From: Fothergill, Anne
Sent: Thursday, July 10, 2008 10:19 AM
To: 'pasolis@aol.com'
Subject: 8822 1st Avenue

Staff Item
July 9, 2008
Anne Fothergill

SUBJECT: Historic Area Work Permit #463222 - Addition and alterations to house

MONTGOMERY COUNTY HISTORIC PRESERVATION COMMISSION
STAFF REPORT

Staff Item
July 9, 2008
Anne Fothergill

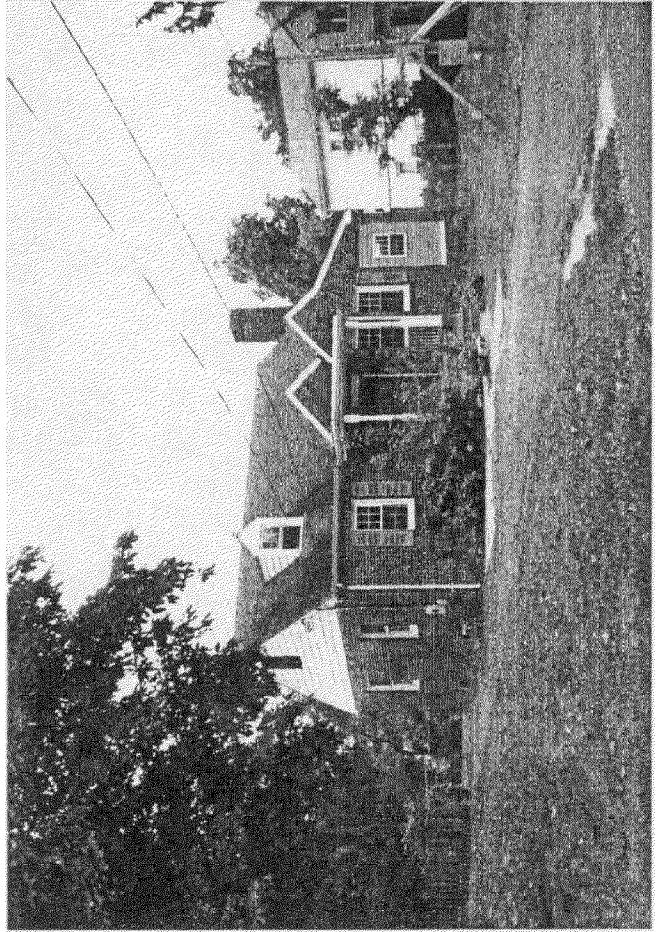
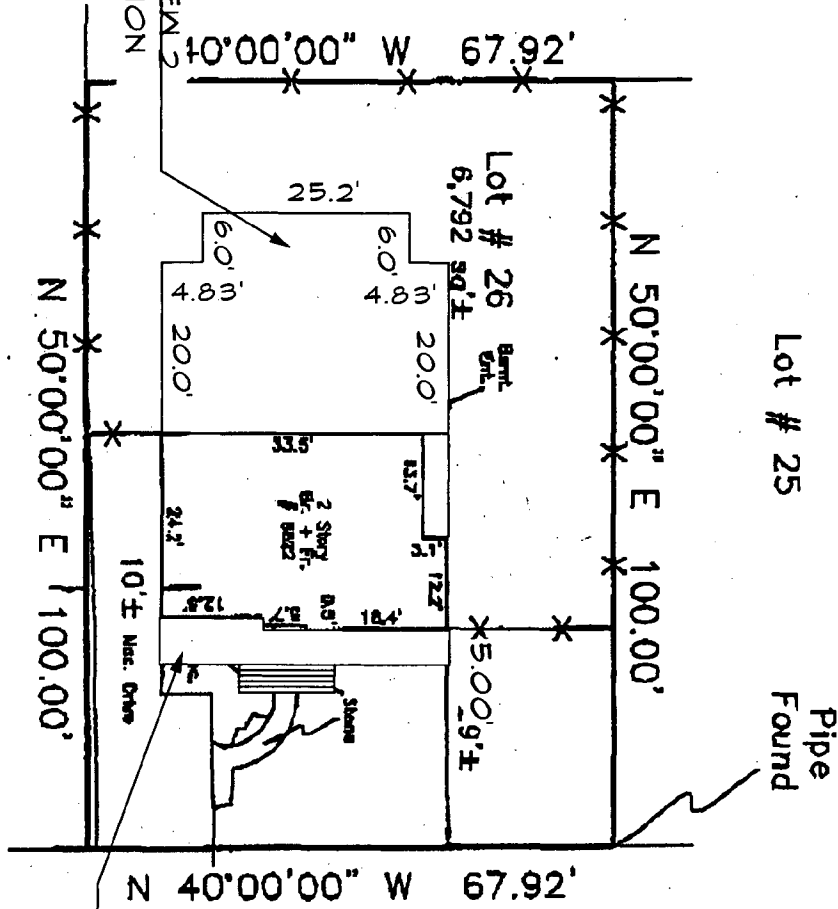
However, they did not approve the brick driveway side extension for the parking/turnaround area. If you want to come back to them to request that, you will need to submit a HAWP application. But as I mentioned I do not expect that they will approve it.

Also, they were concerned about the amount of impervious surface with all the new brick in back. If the patio size could be reduced any to reduce impervious areas, that would be recommended.

- Change driveway material from asphalt to brick; remove driveway extension from left side of the house and enlarge driveway to area in front of the house for turnaround area
- Install brick patio at rear of house
- Install wood arbor on patio at rear of house

- 1) Remove the existing asphalt driveway
- 2) Install a brick paver driveway as shown in your plan—to the left of the house where the existing driveway is but stopping at the front of the house
- 3) Install a brick paver patio at the rear of the house with arbor/grill
